Pizza Rework Project

Pizza

1. LDO Rewiring

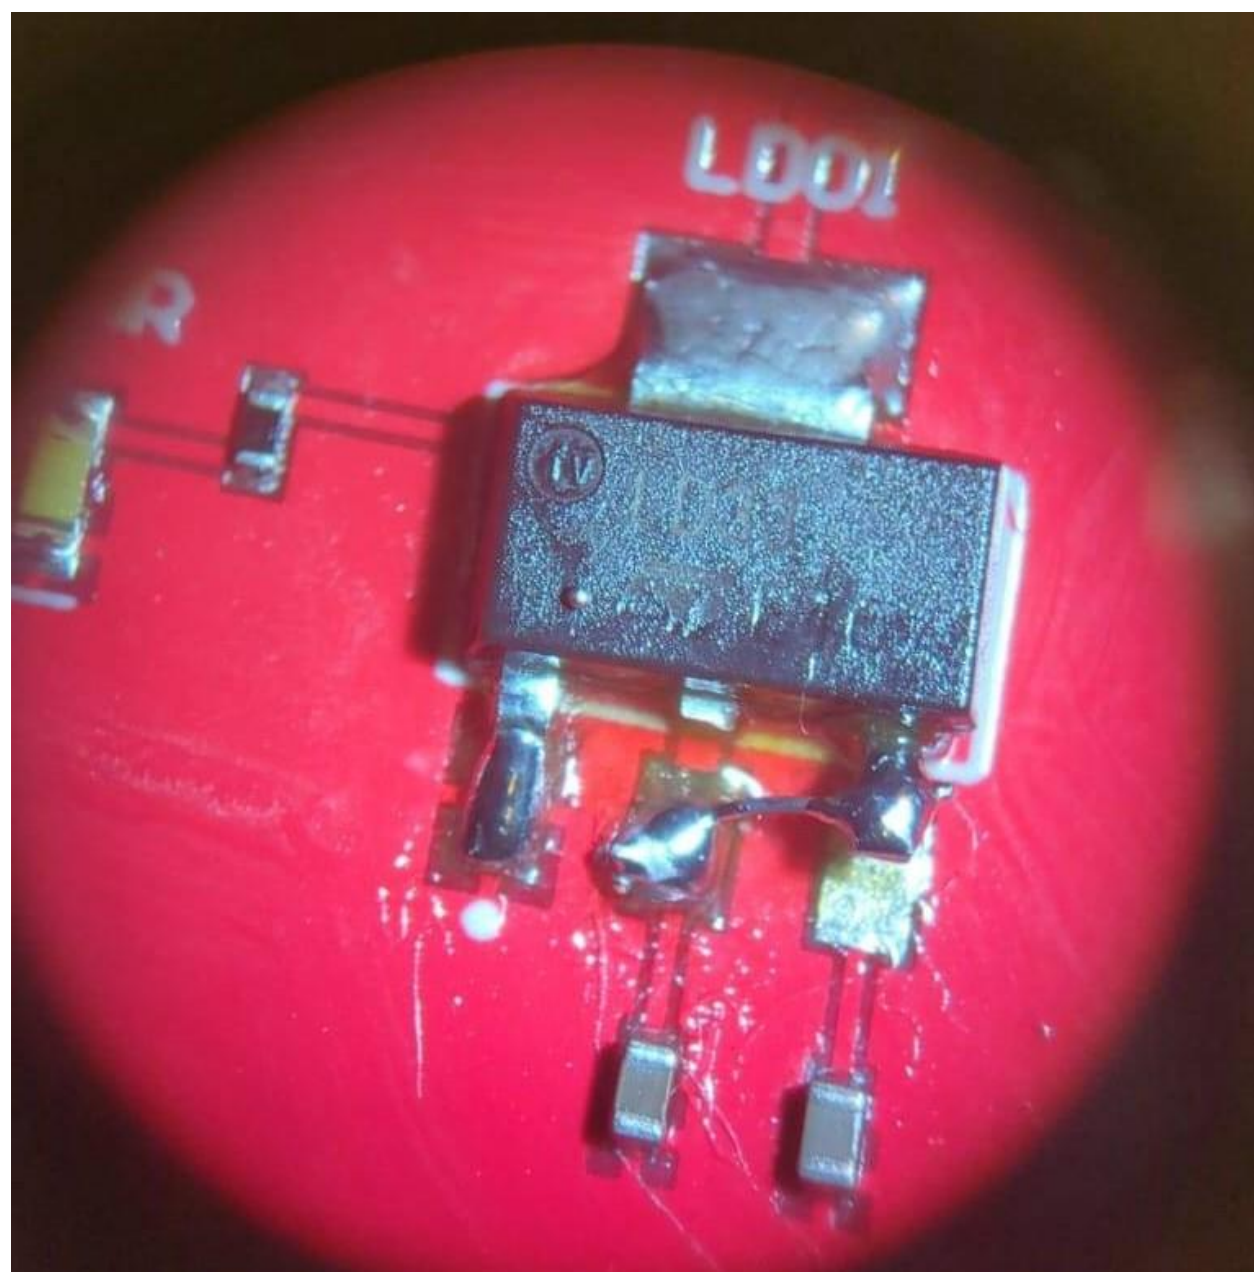
Pads 2 and 3 are inverted, and as a result, pad 4 is incorrectly connected to pad 3 instead of pad 2.

Pins 2 and 4 of the component are internally connected, so it is not necessary to connect both of them.

One solution we have found is to cut pin 2 of the component, lift pin 3, and solder it onto pad 2 (see photo below).

2. Removal of Short Circuits

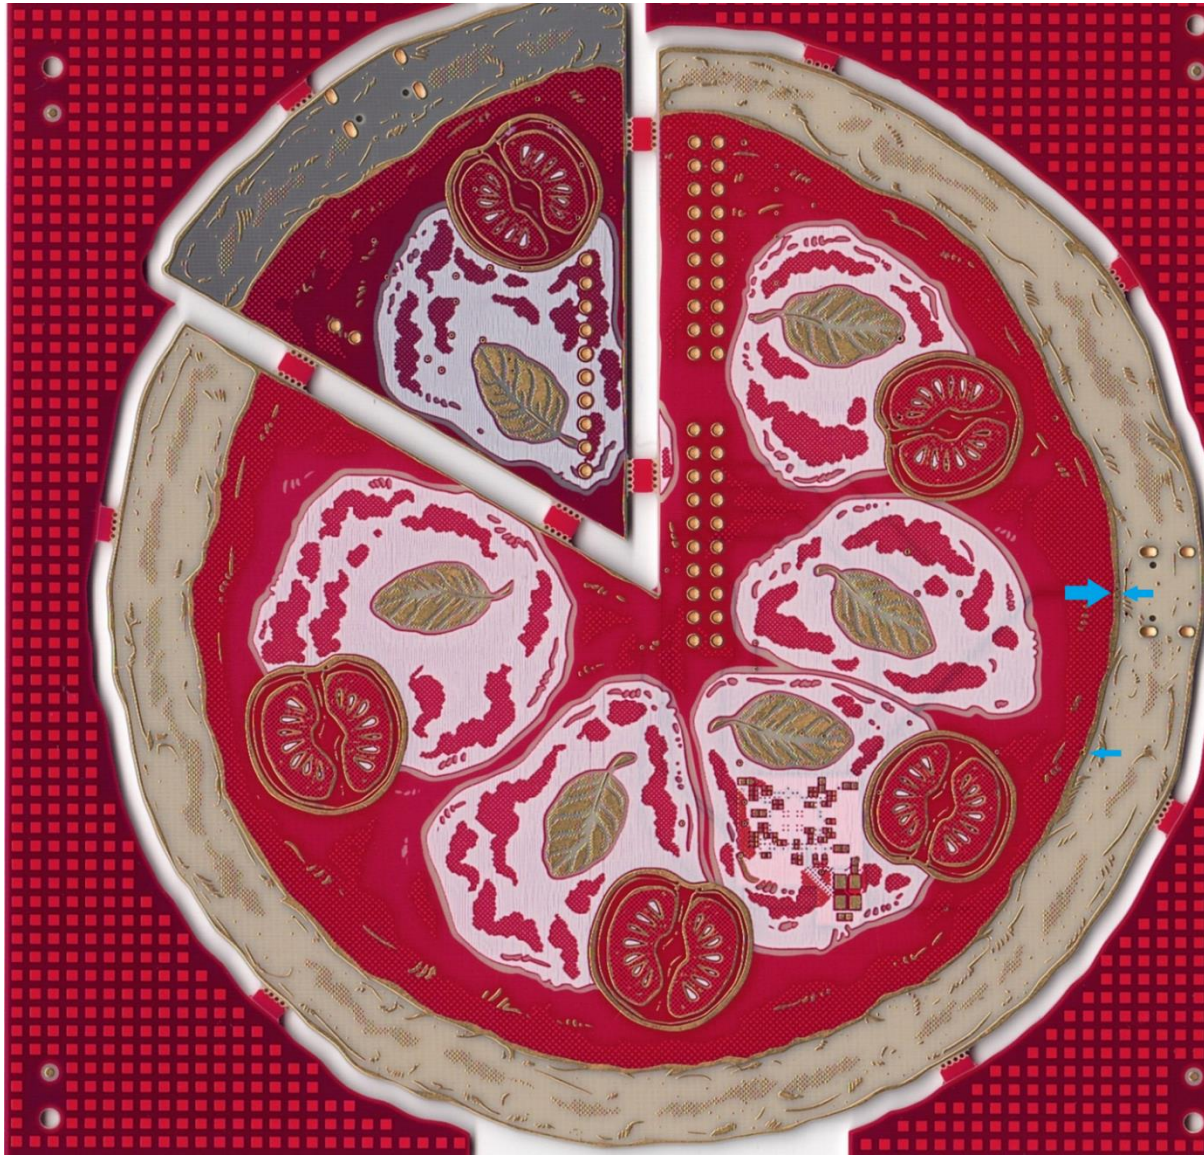
WARNING: Pay attention in the case of the two nearby vias, because on the layer immediately below, there are traces connected to them.

There is a short circuit on the front of the board due to some vias ending on the graphic design. It can be easily resolved by cutting a few traces on the top layer.

The two nearby arrows indicate two vias that intersect the edge of the pad, while the arrow below points to another via that should be isolated.

Particular attention must be paid to the two adjacent vias because they have a trace on the layer immediately below.

3. Quartz Oscillator Rotation

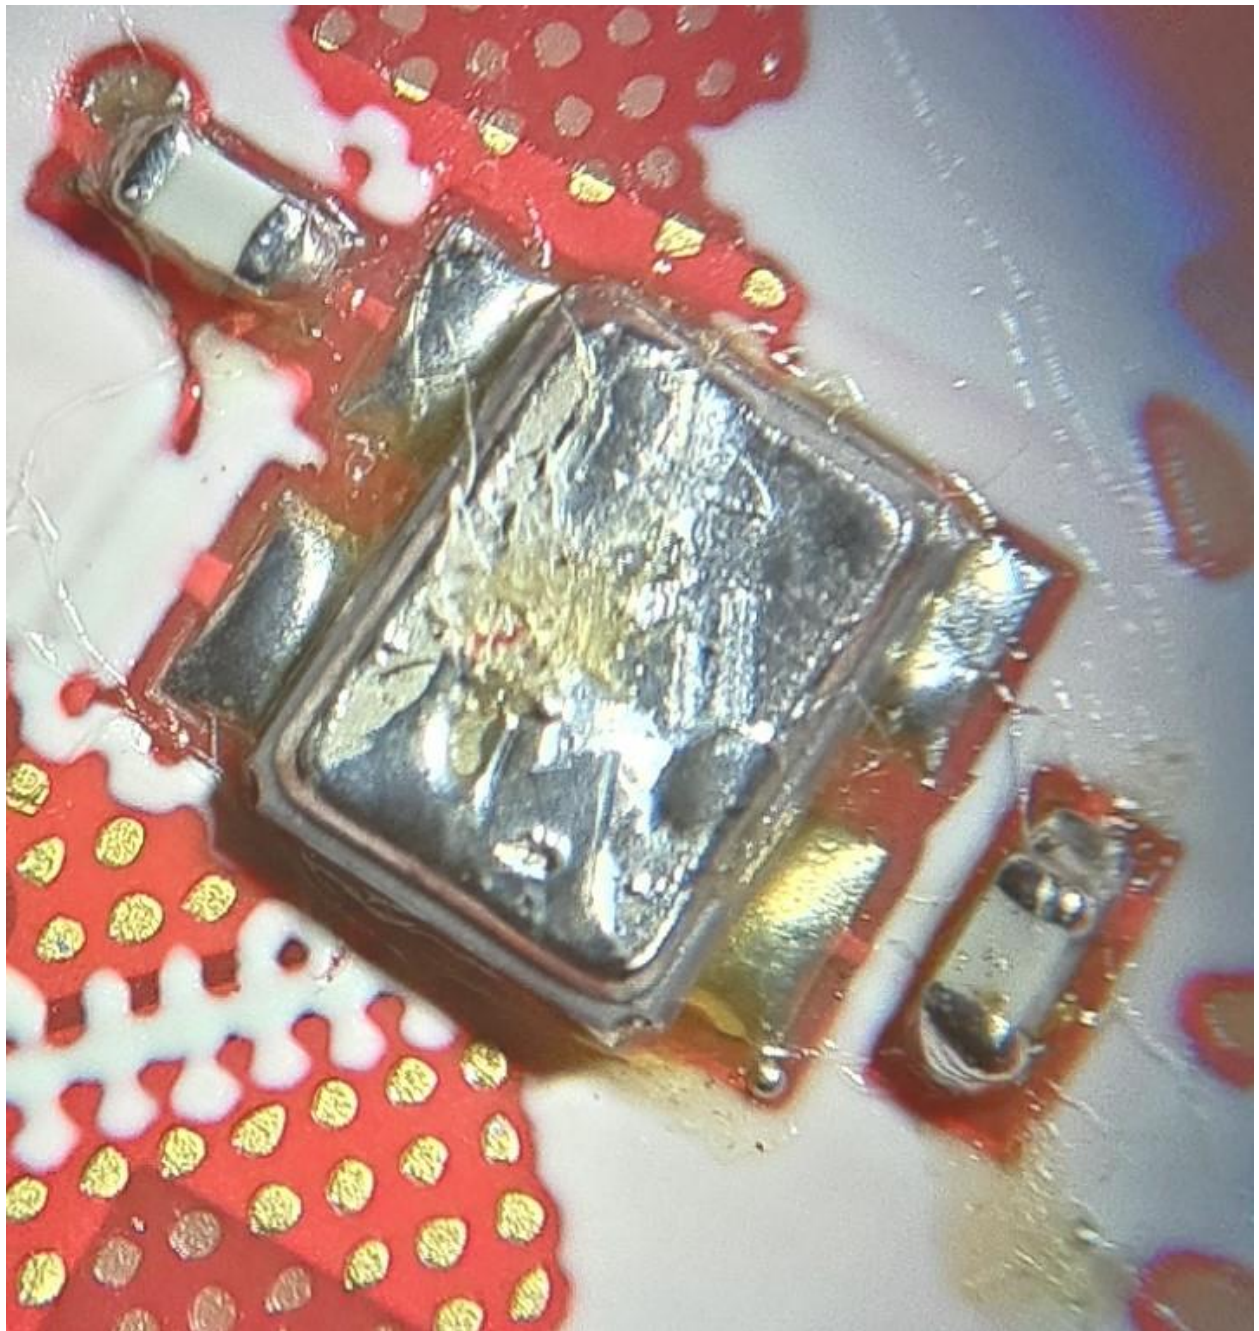
WARNING: It is highly discouraged to use a hot air station, as this area contains a large copper rectangle connected to several vias leading to the SEcube. This would transfer a lot of heat, potentially damaging it.

The quartz oscillator is installed in the wrong direction. To fix it, it needs to be rotated by 90 degrees. The footprint allows for good compatibility even in that orientation.

Result:

4. Capacitor Removal

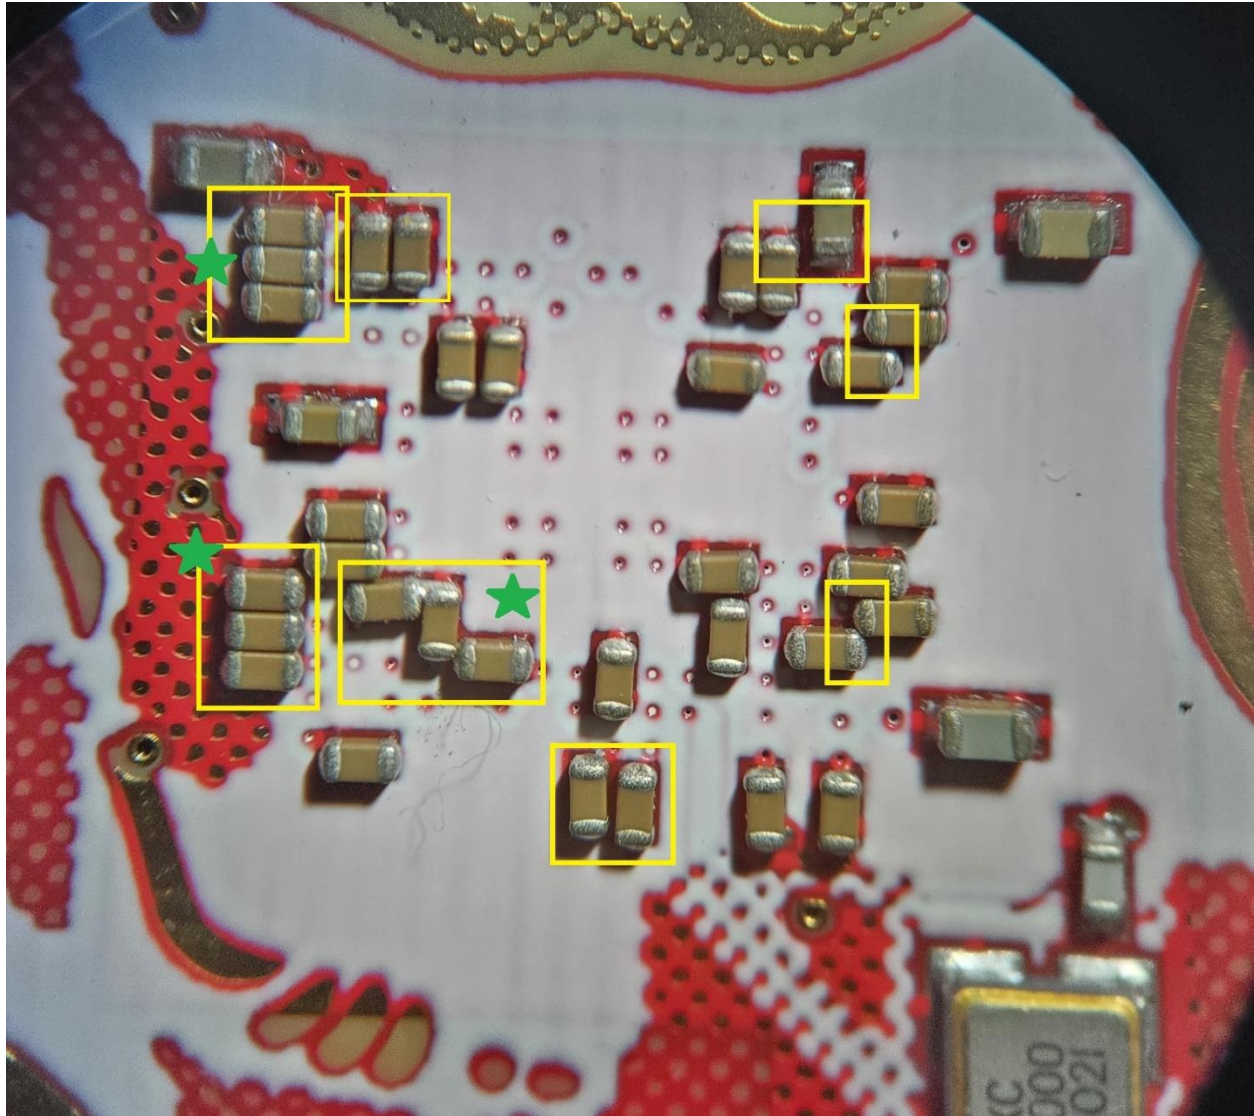
WARNING: It is highly discouraged to use a hot air station, as this area contains a large copper rectangle connected to several vias leading to the SEcube. This would transfer a lot of heat, potentially damaging it.

The extreme proximity of the capacitors under the SEcube (BGA microchip) on the pad has caused the formation of solder bridges between some pads. The groups of capacitors in the yellow squares are problematic; those marked with a green star definitely need to be addressed, while the others depend on the situation of the individual board.

Not all capacitors are strictly necessary; the goal is to keep as many as possible.

In the case of triplets (all those with the star), it is suggested to remove the central capacitor. For the other groups, it is recommended to proceed only if necessary and to prioritize removal in this order, referring to the CAD view with the following colors: capacitors with a white-blue checkered pad, capacitors with a red-blue checkered pad, and others.

2. Removal of Short Circuits

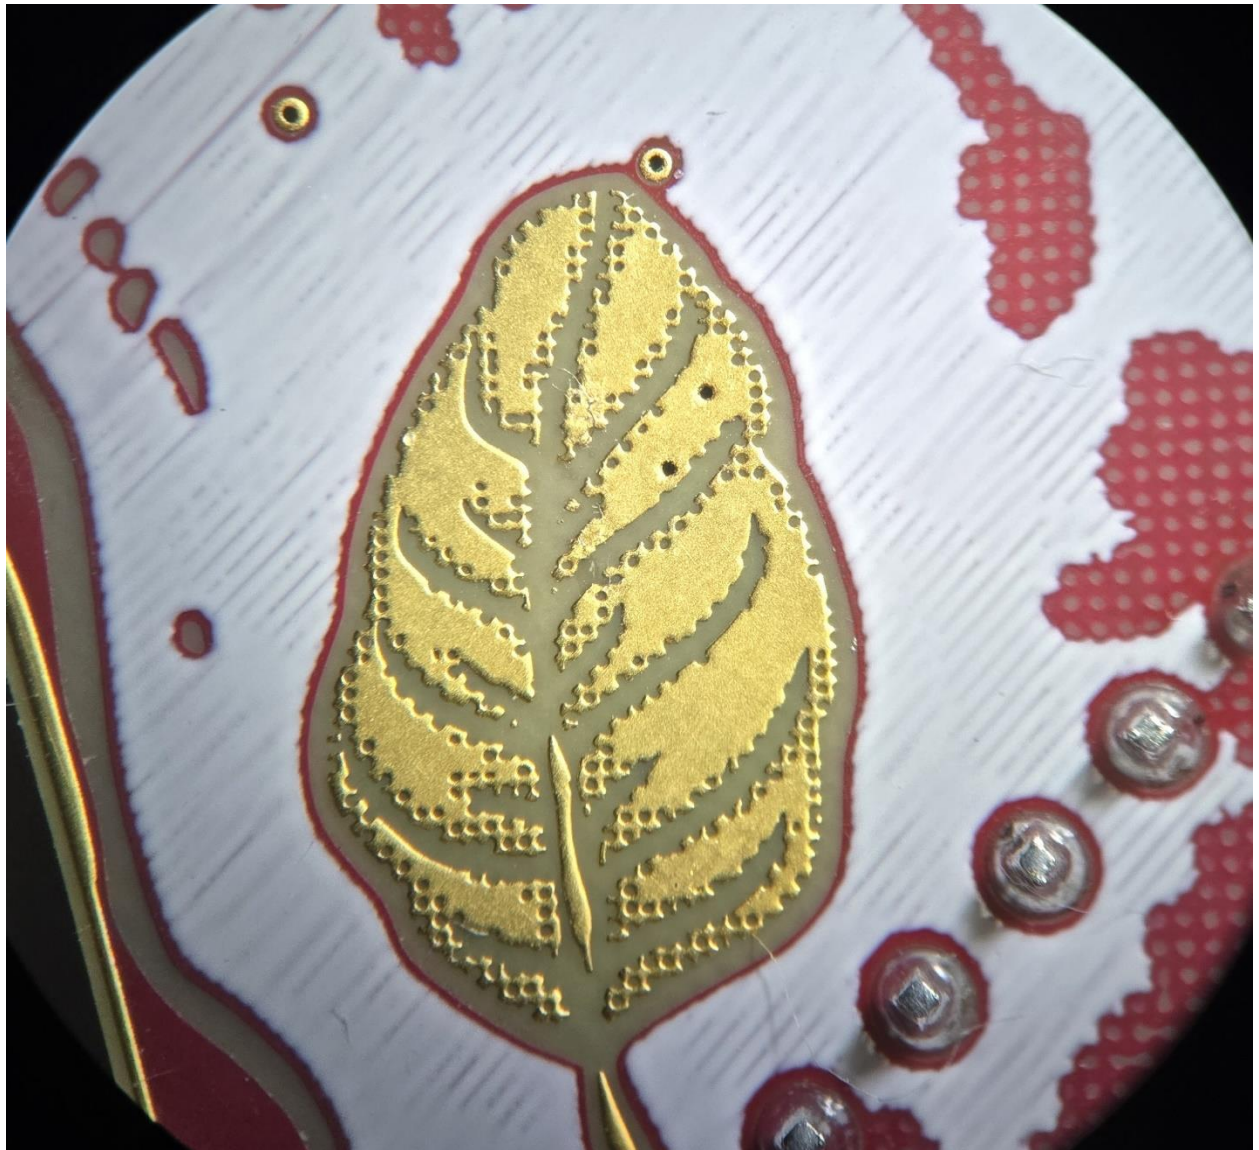
There are short circuits on the front of the board due to some vias ending on the graphic design. They can be easily resolved by cutting a few traces on the top layer.

The blue arrows indicate the problematic vias, while the green ones mark the two points that I consider best for cutting the traces, as they are very thin (in the photo, the modification to the vias on the "tomato" has already been applied).

5. Quartz Oscillator Rotation

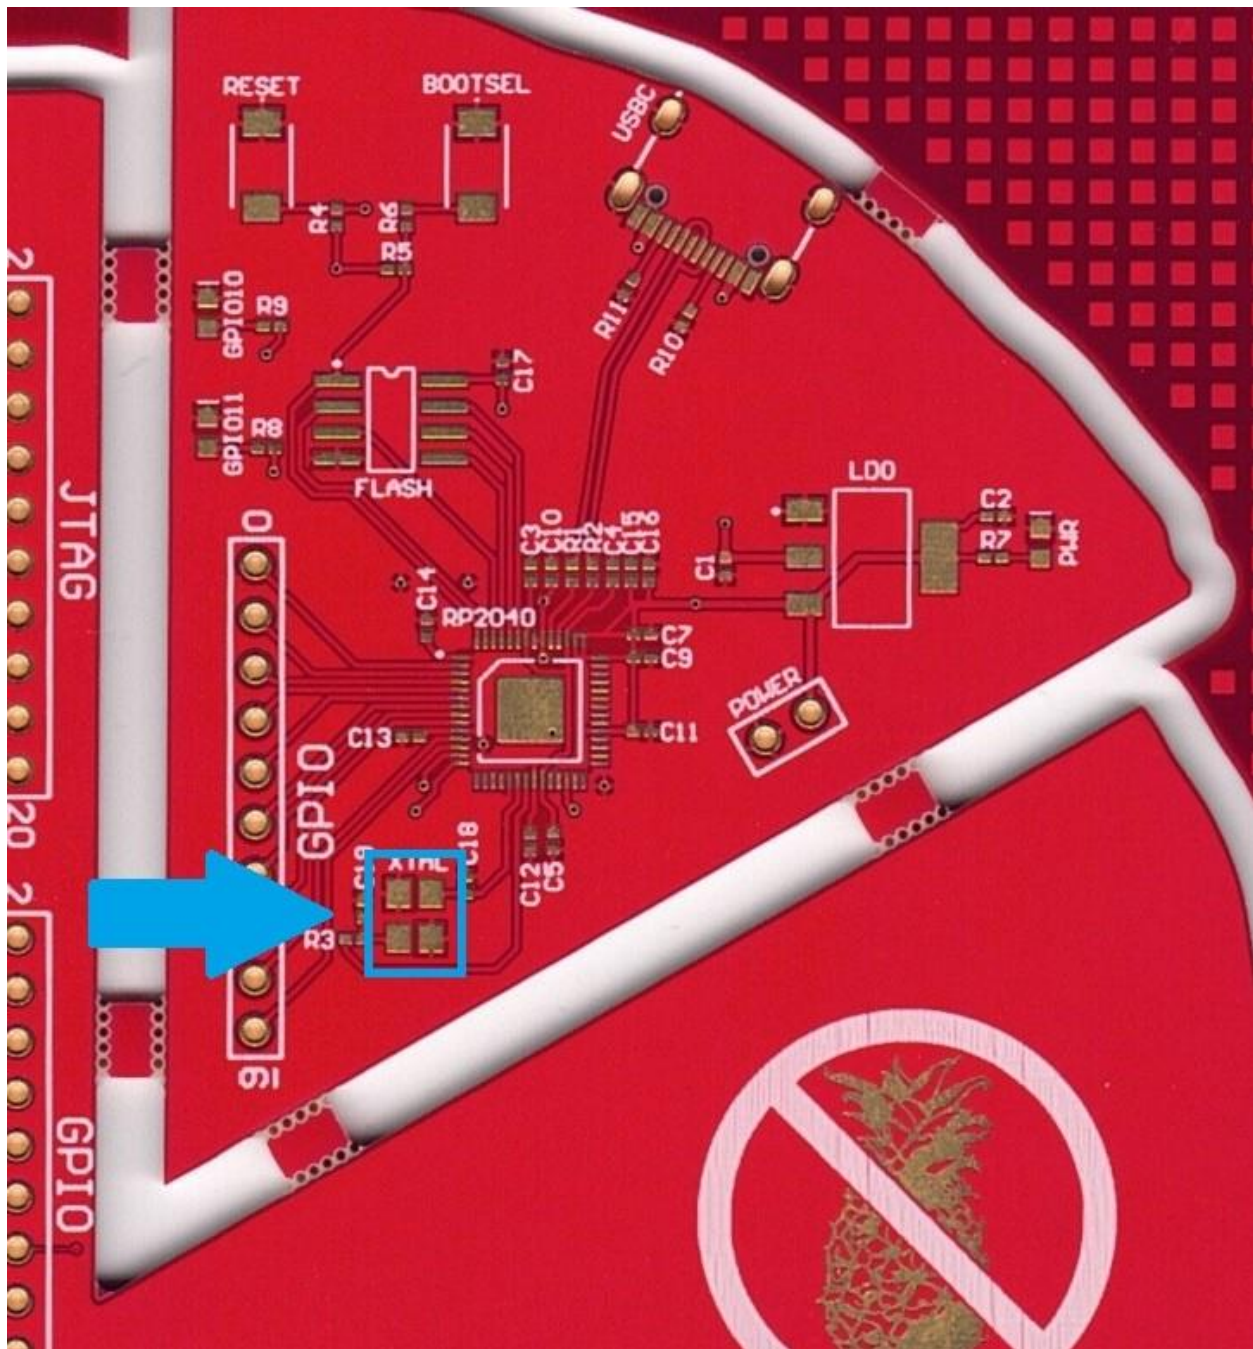
Refer to the Quartz Oscillator Rotation of the Pizza.

Result:
